The application of 4M change

Supplier: Zhe Jiang Rectron Electronic Co., Ltd

Item	RBUM , RS4M , RS6M package (封装)	Supplier					
P/N	RBU4M, RBU6M, RBU8M, RBU10M, RBU15M, RS4M, RS6M, RS8M, RS10M, RS15M, RS20M, RS25M, RS35M related series part no (相关料号)	GM	SALE	PURCHASE	PE	QRA	Prepared
		刘德明	刘年富	陆良宏	金少伟	周松	周松

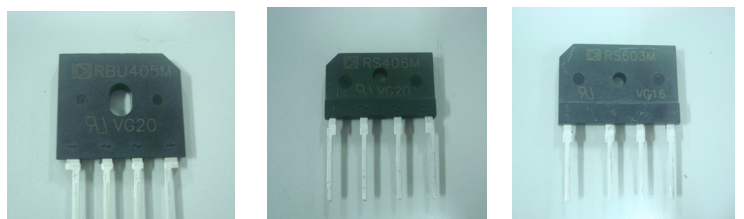
因油墨印字偶有印字不牢，印字不全，过炉后印字脱落等情况，我司故将此三种主要桥式封装产品全部改成由油墨印字改成镭射印字，新货将从8月份（第30周）开始供应，起始产品周期从VG30开始

Due poor marking (like incomplete marking, fall off after soldering) defective issue had been happen in ink marking bridge rectifier products, so RECTRON will change from ink marking to laser marking. the first starting D/C (producing data code) will begin from VG30
